# **Lime Down Solar Park**

**Planning Inspectorate Reference:  
EN010168**

**Wiltshire Council Comments on Submissions  
Received at Deadlines 2a and 3**

**Deadline 4 (10 July 2026)**

**Figure 1.** Extract from Hedgerow Height Plan (Rev A) (Sheet 18 of 23) [\[REP3-128\]](#)

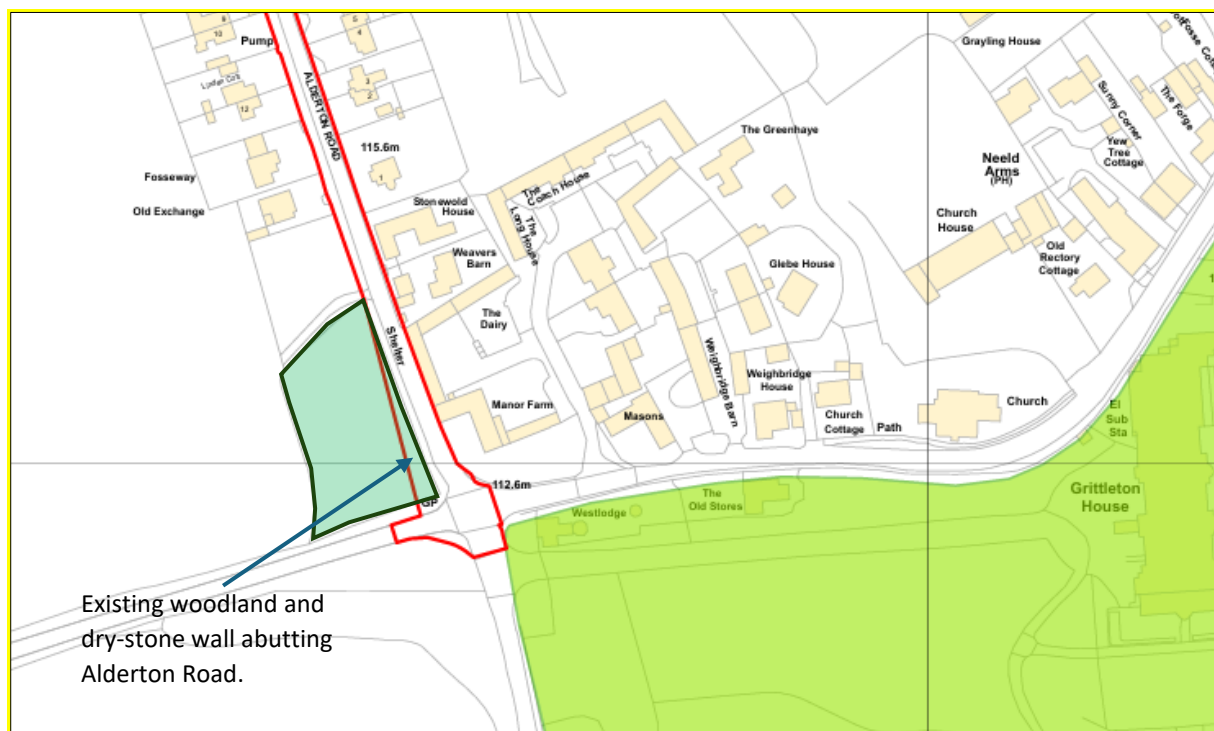
20.53. During the course of ASI1, a specific area of woodland located at the southwestern edge of Grittleton, was identified by a Grittleton Parish Council representative, Figure 1 (below). They pointed out that the eastern side of this area of mature woodland, will be impacted by the planned construction works to widen the Grittleton Crossroads junction layout, to facilitate the planned AIL / HGV construction route to Lime Down areas A, B and C along Alderton Road. The council further identifies that an existing dry-stone wall is also present bordering the northwest quadrant of this crossroads separating the woodland from the highway within DCO limits which may also be impacted.

- 20.54. The council highlights it is currently unclear as to the extent of likely required tree removals or length of dry-stone wall required to facilitate the junction 'improvement' works, and correspondingly what the effects will be for these existing woodland or drystone wall landscape fabric components.
